Economic Commission for Europe**Inland Transport Committee****World Forum for Harmonization of Vehicle Regulations****Working Party on Lighting and Light-Signalling****Sixty-eighth session**

Regulation No. 48 (Installation of lighting and light-signalling devices):**Proposal for amendments to the 05 series of amendments****Proposal for Supplement 3 to the 05 series of amendments to Regulation No. 48 (Installation of lighting and light-signalling devices)****Submitted by the expert from Poland***

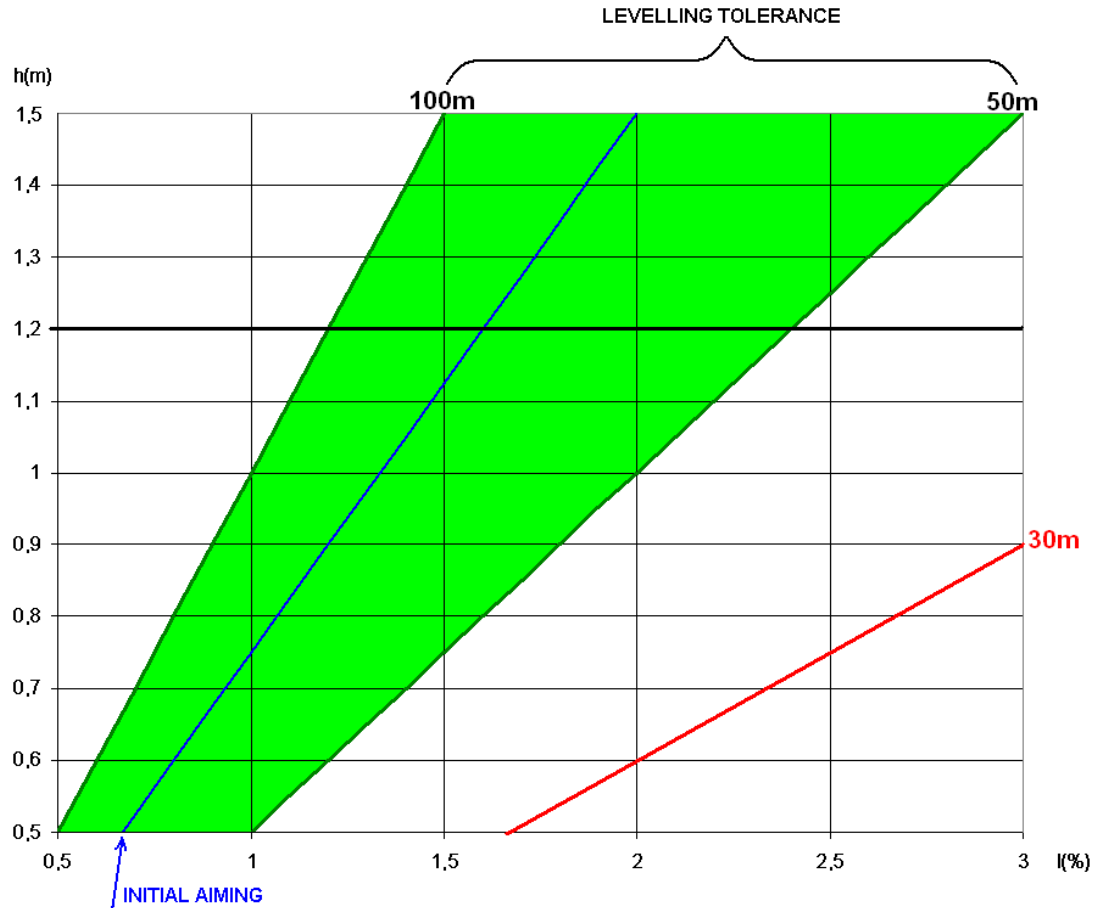
Paragraph 6.2.6.1.2., amend to read:

"6.2.6.1.2. Depending on the mounting height in metres (h) of the dipped-beam headlamp reference axis, the vertical inclination of the cut-off of the dipped beam, (in the direction of the reference axis) measured on the unladen vehicles, taking in account 0.1 per cent accuracy, shall have the value of initial aiming for which the horizontal part of cut-off crosses the surface of flat horizontal road at the distance of 75 m from the headlamp.

The aiming limits under all the static conditions of Annex 5 shall be such that the distance of crossing of the vertical part of cut-off with the road surface shall remain between [50 m] and [100 m] including aiming inaccuracy.

The crossing distance could be lower but not less than [25 m] under the condition that there will be a note in the car, located in the place easily visible for the driver, expressing the shortest visibility distance e.g.: "SAFE USE OF PASSING BEAM HEADLAMPS DURING NIGHT TIME IN THIS VEHICLE ON A STRAIGHT ROAD UNDER HEADLAMP MAINTENANCE AS PRESCRIBED IN VEHICLE USER MANUAL IS RESTRICTED TO A VISIBILITY DISTANCE OF m" [WHICH REFLECTS A MAXIMUM SPEED OF ... km/h]".

The same value of minimum visibility distance should be declared in paragraph 10.9. of the communication form (see Annex 1) and in the vehicle user manual. It is also possible on the same way to declare a longer than minimum required visibility distance according applicant knowledge.

~~h < 0.8~~

~~limits: between 0.5 per cent and 2.5 per cent~~

~~initial aiming: between 1.0 per cent and 1.5 per cent~~

~~0.8 < h < 1.0~~

~~limits: between 0.5 per cent and 2.5 per cent~~

~~initial aiming: between 1.0 per cent and 1.5 per cent~~

~~Or, at the discretion of the manufacturer,~~

~~limits: between 1.0 per cent and 3.0 per cent~~

~~initial aiming: between 1.5 per cent and 2.0 per cent~~

~~The application for the vehicle type approval shall, in this case, contain information as to which of the two alternatives is to be used.~~

~~h > 1.0~~
